MANDATORY SERVICE BULLETIN

MSB 42-095

MSB 42NG-026

Replacement of MLG damper nut.

Picture 3

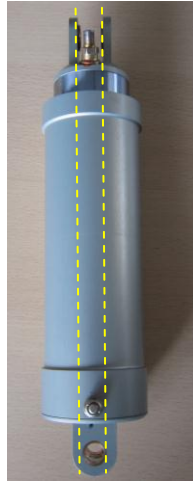
8	Allow Loctite to cure before filling (Minimum cure time 12 hours).
9	Install the bottom cap with the bolt, washer and nut.
10	Remove the spacer from piston tube.
11	Install the charging valve with a new O-Ring MS 28775-010.
12	<p>Adjust the direction of the piston tube to the cylinder tube acc. to picture 3.</p> <p>Note: The charging valve must be aligned with the nut from the bolt holding the bottom cap.</p>

Drawing Number:	Supplier
D60-3277-10-00_01	BusekShamban

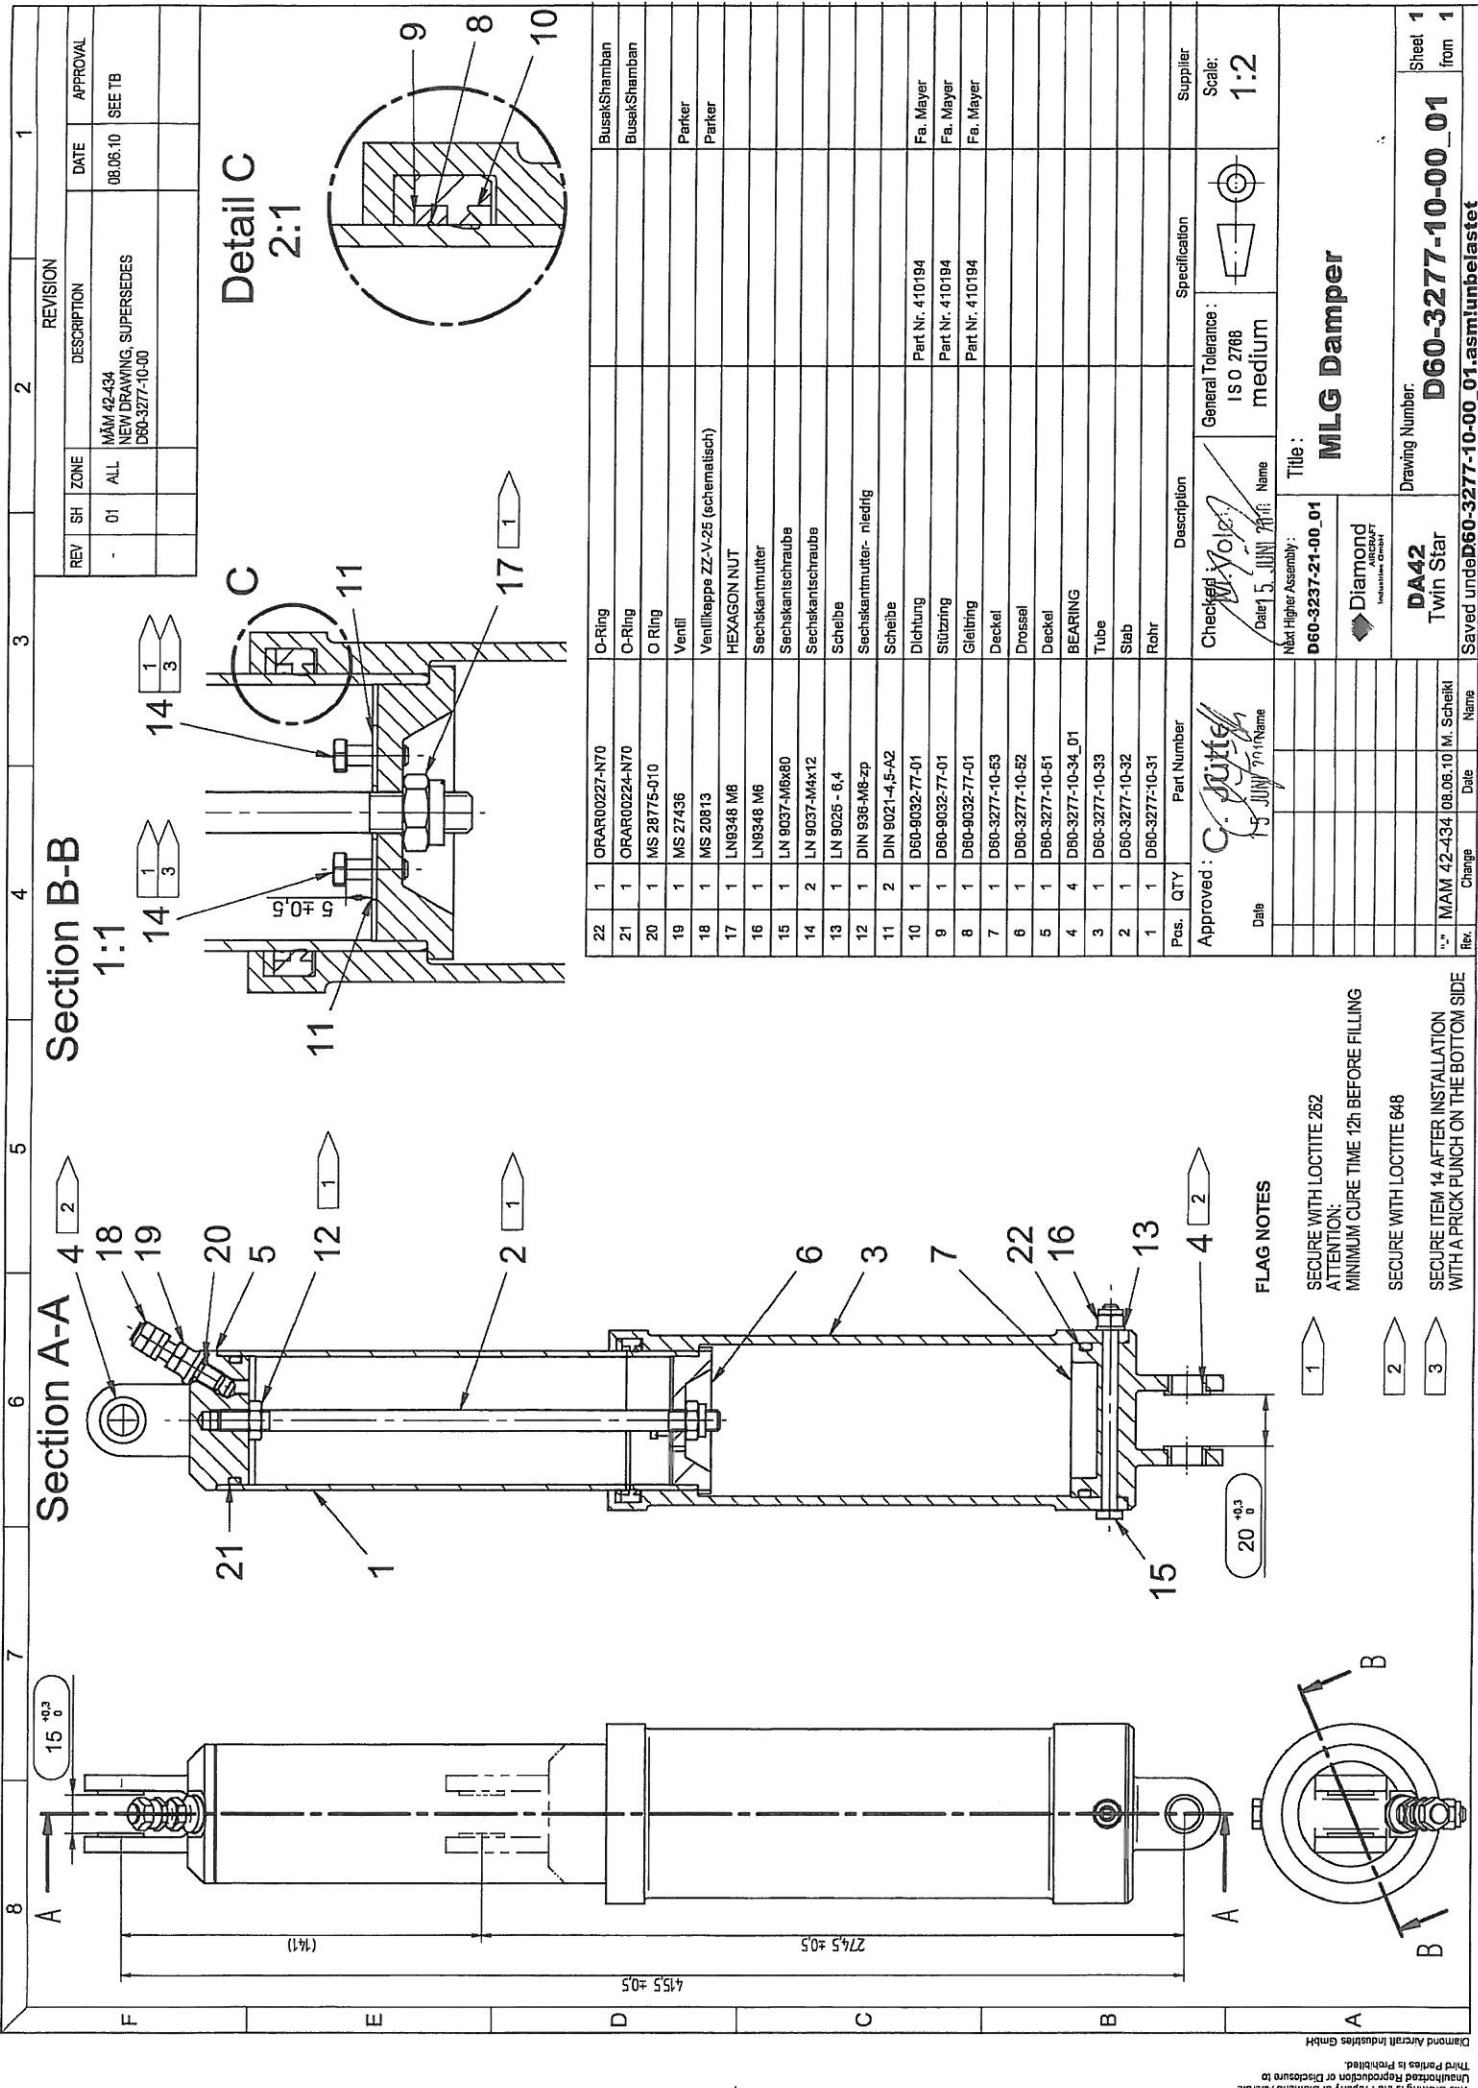
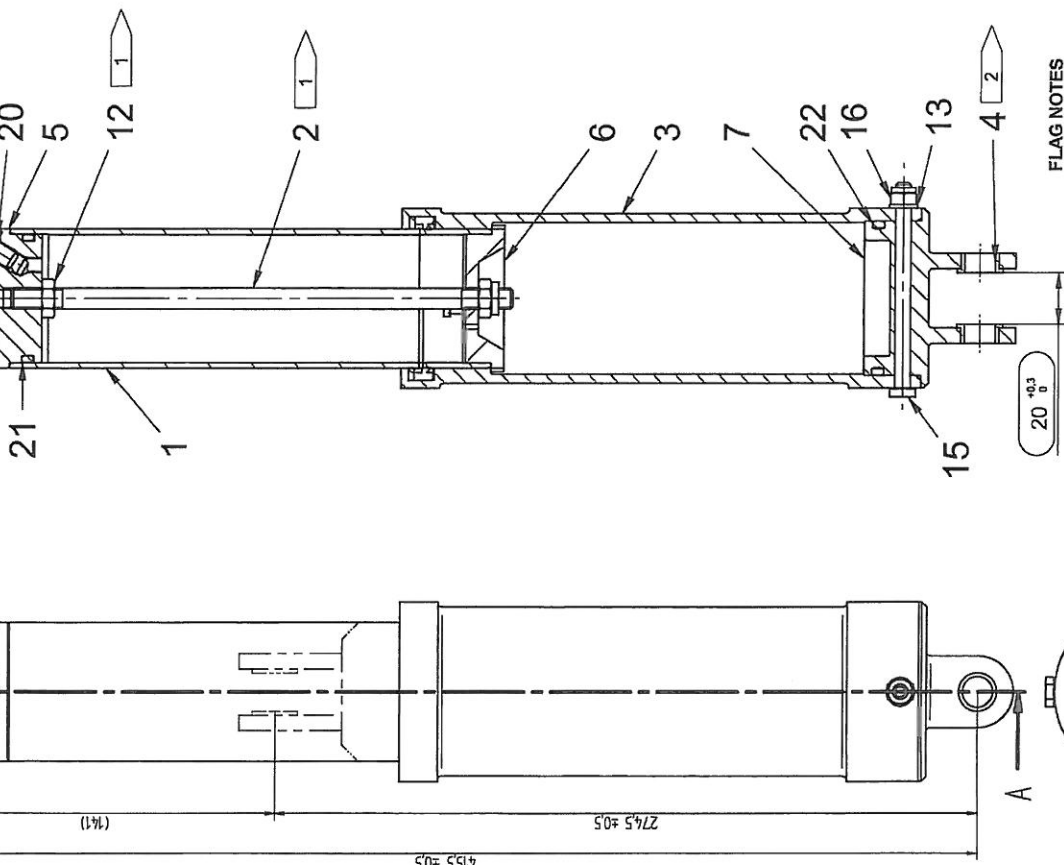
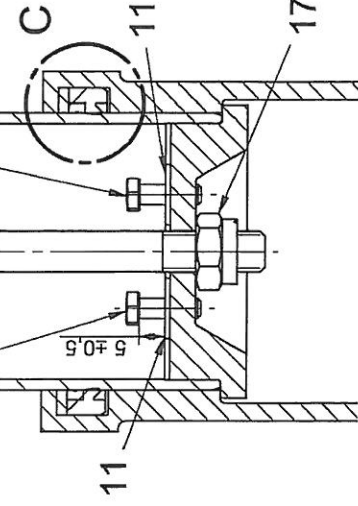
- 1 SECURE WITH LOCTITE 262
ATTENTION:
MINIMUM CURE TIME 12h BEFORE FILLING
- 2 SECURE WITH LOCTITE 648
- 3 SECURE ITEM 14 AFTER INSTALLATION
WITH A PRICK PUNCH ON THE BOTTOM SIDE

REV	SH	ZONE	DESCRIPTION	DATE	APPROVAL
-	01	ALL	MAM 42-434 NEW DRAWING, SUPERSEDES D60-3277-10-00	08.06.10	SEE TB
